APPROXIMATE WEIGHT RANGE-0.931 - 1.137 kg/m		UNSPECIFIED RADIUS 0.50 mm	
 SYMBOL OF QUALITY AN ISO 9001 COMPANY	JINDAL ALUMINIUM LTD. BANGALORE-560073 (INDIA)		NAME
		DRAWN	J.P.KAUSHIK
1. ALL DIMENSIONS ARE IN mm. 2. ROUND OFF ALL SHARP CORNERS WITH 0.40 mm. 3. TOLERANCES WILL BE AS PER IS:3965-1981 UNLESS OTHERWISE SPECIFIED		CHECKED	
		APPROVED	B.NATARAJA
PARTY'S NAME	SWASTIKA AUTOMATICS, FARIDABAD	SCALE	3:1
		AREA mm ²	383.126
PARTY'S DRAWING No.	XL HC839YXAAA-00	PERIMETER mm.	101.172
		WEIGHT kg/m	1.034
ALLOY & TEMPER	6005 T5	DRAWING No.	SECTION No.
		P-22335	
DESCRIPTION	AUTOMOBILE SECTION	43509	43509(ISSUE-3)

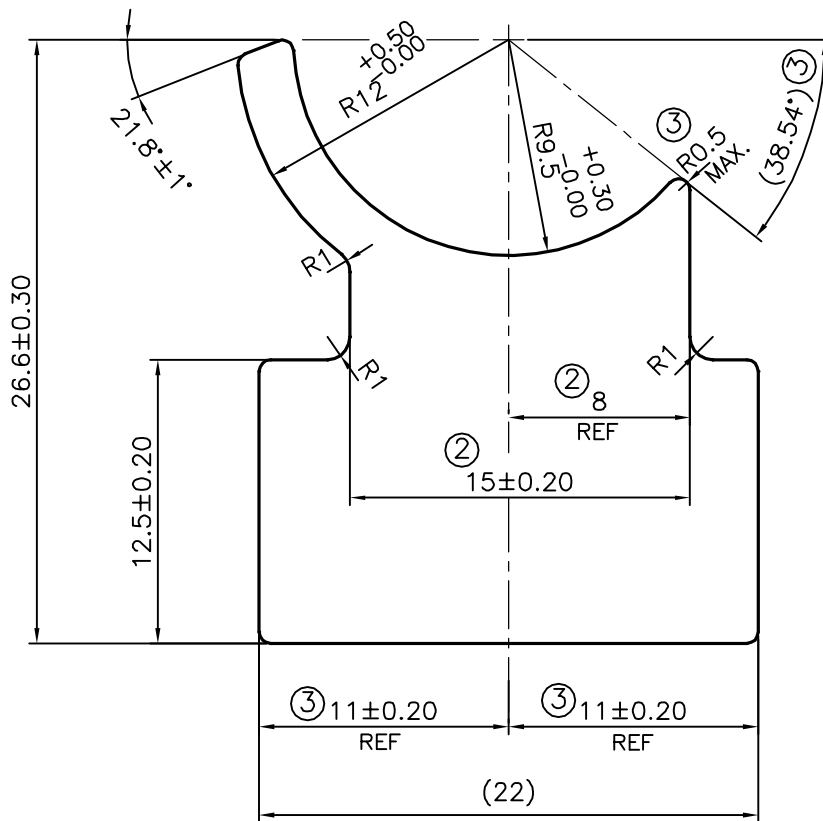
P-22335	ISSUE-2 ②	
43509	DIMENSIONS CHANGED FROM $14^{\pm 0.20}$ mm TO $15^{\pm 0.20}$ mm DIMENSION ADDED 8.0 mm & ANGLE ADDED 39° WEIGHT ALSO CHANGED FROM 1.012 TO 1.034 kg/m	
	ISSUE-3 ③ DIMENSION ADDED 11.0 ± 0.20 mm & RADIUS CHANGED FROM R0.55 TO R0.50 ANGLE CHANGED FROM 39° TO 38.54°
